**Project #22-017  
Reeder Warehouse  
Located at 815 West 1455 N**

*Project Name:* Reeder Warehouse  
*Proponent / Owner:* Courtney Wallace / Mark Reeder Holdings LLC  
*Project Address:* 815 West 1455 N  
*Request:* Design Review Permit  
*Current Zoning:* Industrial Park (IP)  
*Type of Action:* Quasi-Judicial  
*Hearing Date:* March 24, 2022  
*Submitted By:* Tanya Rice, Planner II

Staff recommends that the Planning Commission **conditionally approve** a Design Review Permit for Project #22-017, Reeder Warehouse Building in the Industrial Park (IP) zone located at 815 West 1455 North, TIN #04-193-0001.

Site Plan

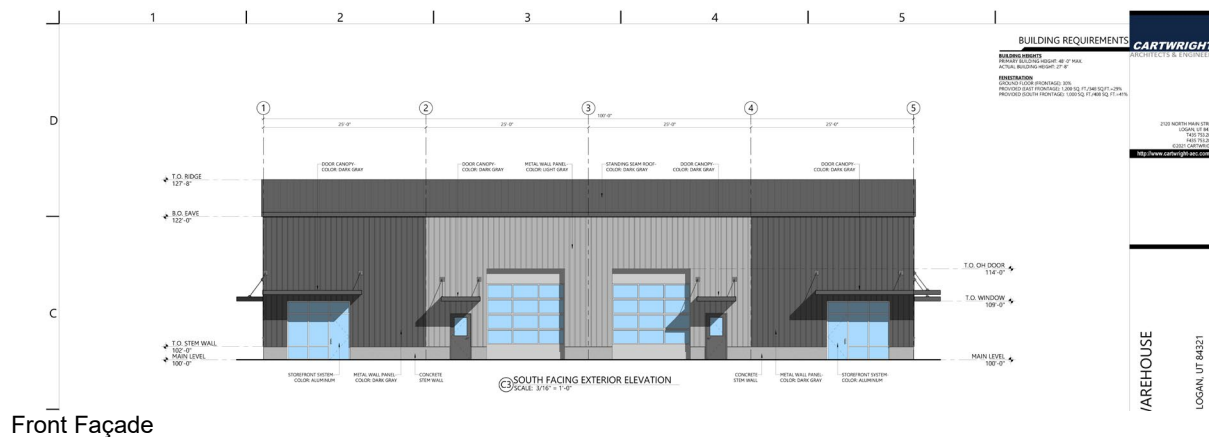
Vehicular access to the project site is proposed from 1455 North, a private roadway serving seven parcels. Access into the site will be through a cross access easement shared with the adjacent property to the west.

The LDC 17.30 requires new developments to include safe and convenient pedestrian circulation from building entrances to one another and to adjacent streets, parking areas and other outdoor gathering areas. The proposed site plan includes a sidewalk connection from the front of the building to the parking lot and the 800 West sidewalk. An emergency door on the east side of the building is proposed without a sidewalk connection. A walkway shall be constructed to connect this entrance to the 800 West sidewalk and other building entrances. With the addition of this sidewalk, the project complies with the requirements in the LDC.

1. All standard conditions of approval will be recorded with the Design Review and are available in the Community Development Department.
2. Pedestrian walkways shall be constructed to connect all building entrances and the 800 West sidewalk.

A201

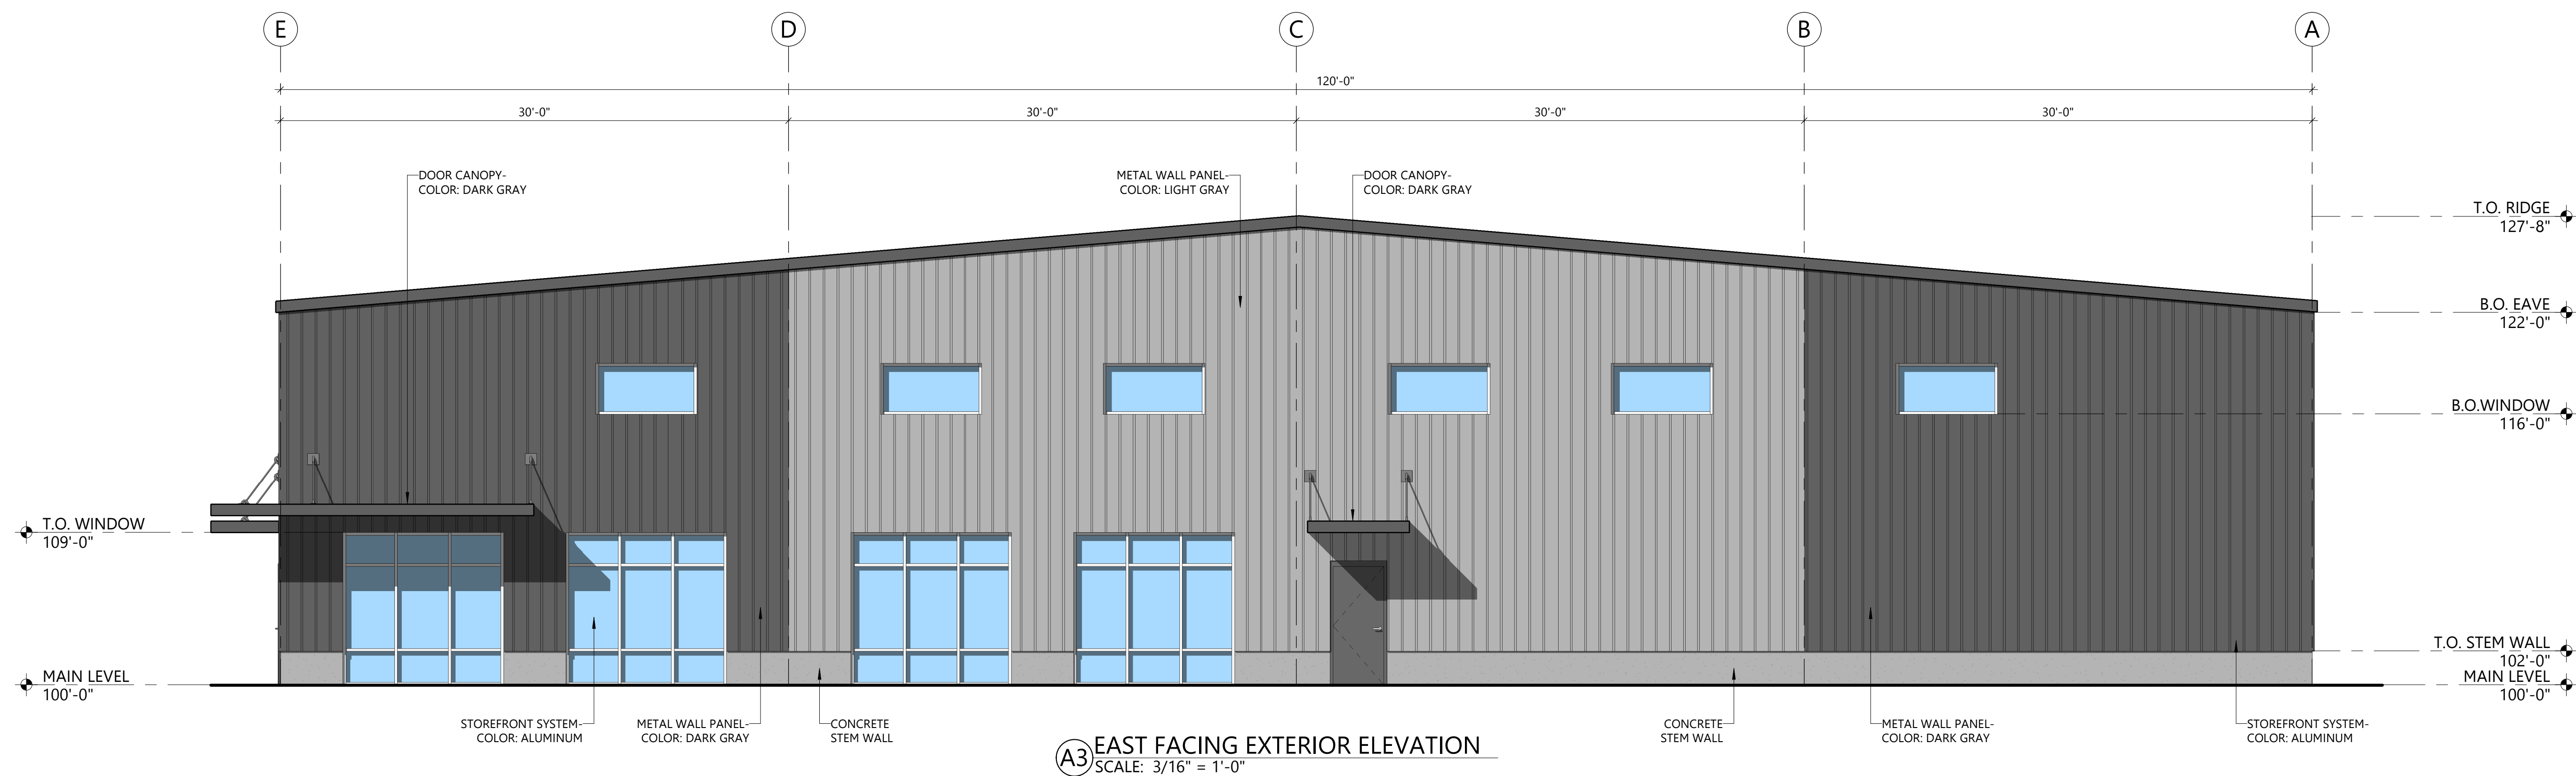
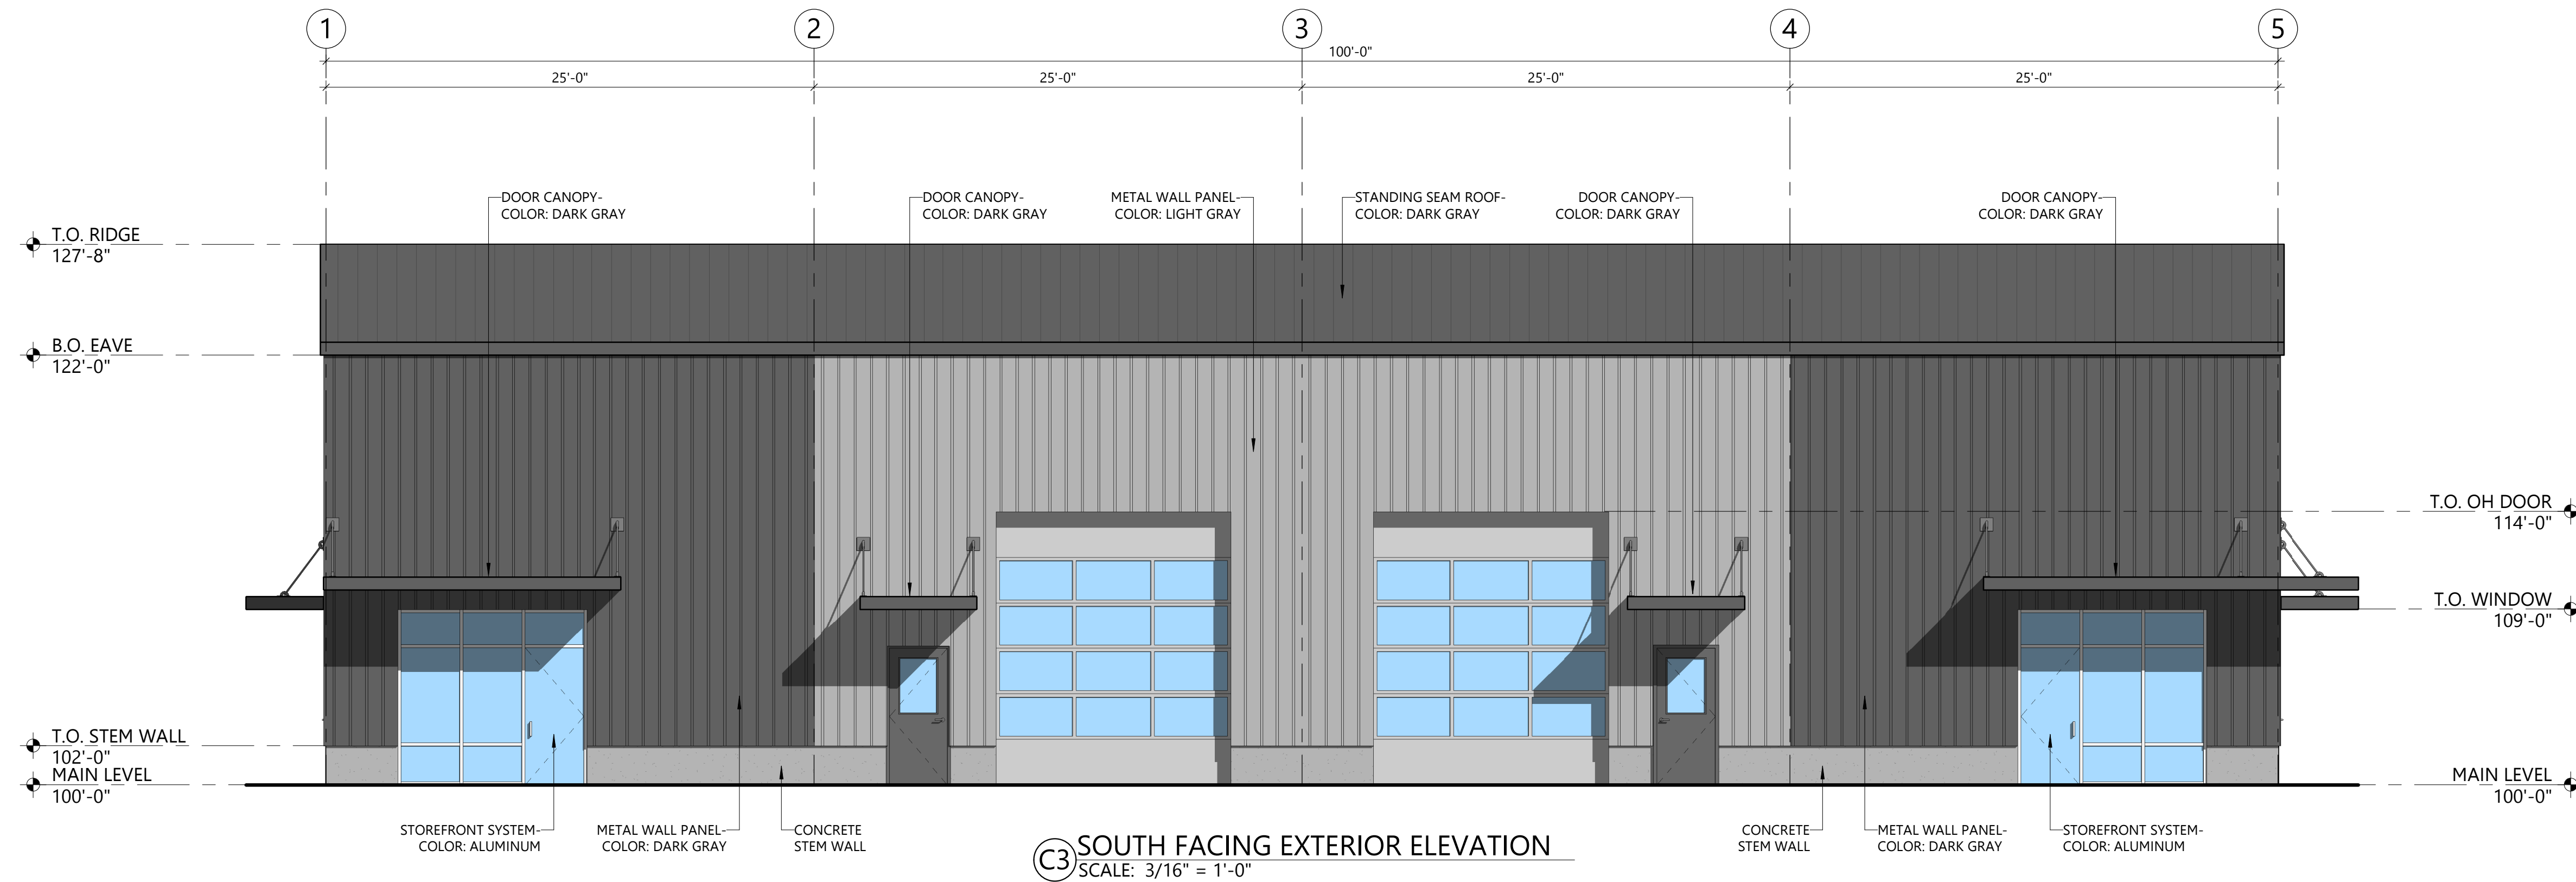
The LDC 17.12.060 requires new buildings in the IP district to be well-designed with high-quality materials. Blank walls exceeding 40 linear feet are prohibited and ground floor street-facing facades shall have a minimum of 30% transparency. Acceptable wall-breaks include windows, balconies, wall articulation or changes in color and materials. The proposed building is one large structure with a standing seam roof. The proposed building material is metal siding with alternating tones of grey. The facades show wall-breaks and other features at the minimum 40 linear foot increments. The building's southern façade facing 1455 North is shown with 41% transparency and the 800 West facing façade is shown with 29% transparency, just under the 30% LDC standard. Staff recommends the Commission use their discretion to allow for 29% fenestration. As conditioned with 29% fenestration on the east façade, the building design meets the requirements in the LDC.

3. Planning commission permits 29% fenestration on the east façade of the building.
4. A performance landscaping plan, prepared in accordance with §17.32 of the LDC, shall be submitted for approval to the Community Development Department prior to the issuance of the building permit. The plan shall include the following:
